Access Compliance Report

Public Rights-of-Way

Intersection ID: N/A	Main Street: E MARTIN LUTHER KING JR BV	Cross Street: S DAVIDSON ST	Location: N
ADA ID: 2B7EE367D481	Ramp Type: PerpDiag	Initial Pass/Fail: Fail	Overall Compliance: No
Codes/Mitigation Info/Possible Solution		Field Measurements/Component Compliance

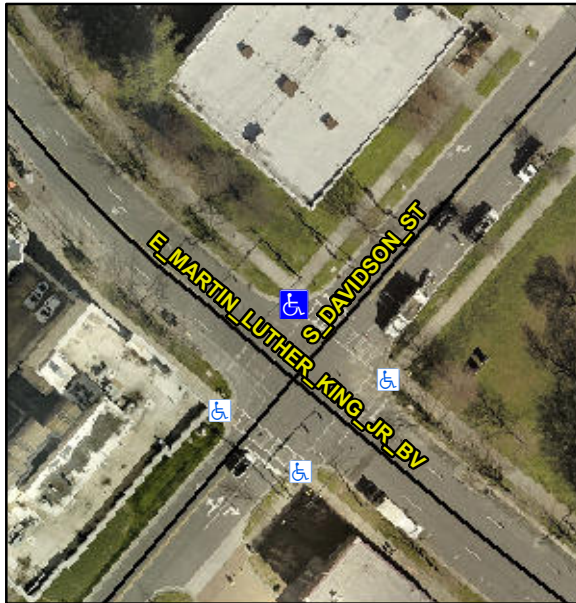
Not Found, R304.2.2, R304.5.3

Compliance	Description	Data	Compliance	Description	Data
N/A	Ramp Length (in)	130.0	No	Ramp Slope (%)	8.9
Yes	Ramp Width (in)	60.0	No	Ramp XSlope (%)	3.8
N/A	Flare Type LT	N/A	N/A	Flare Type RT	N/A
N/A	Flare Slope LT (%)	N/A	N/A	Flare Slope RT (%)	N/A
N/A	Flare Traversable LT?	No	N/A	Flare Traversable RT?	No
N/A	Landing Length (in)	N/A	N/A	DWS Provided?	N/A
N/A	Landing Width (in)	N/A	N/A	DWS Contrast?	N/A
N/A	Landing Slope (%)	N/A	N/A	DWS Length (in)	N/A
N/A	Landing X Slope (%)	N/A	N/A	DWS Full Width?	N/A
N/A	Landing Curb? (Y/N)	N/A	N/A	DWS Offset (in)	N/A
N/A	Shared Landing?	N/A			
N/A	Gutter Ponding?	N/A	N/A	Gutter Slope (%)	N/A
N/A	Gutter Lip Ht (in)	N/A	N/A	Gutter X Slope (%)	N/A
N/A	Painted X Walk1?	Yes	N/A	Painted X Walk2?	Yes
	X Walk 1 Direction	To SW		X Walk 2 Direction	To SE
N/A	X Walk 1 Width (in)	110.0	N/A	X Walk 2 Width (in)	110.0
	X Walk 1 Slope (%)	3.3		X Walk 2 Slope (%)	1.5
	X Walk 1 X Slope (%)	3.0		X Walk 2 X Slope (%)	2.6

Remove & Replace Curb Ramp With Two New Directional Ramps or Equivalent.
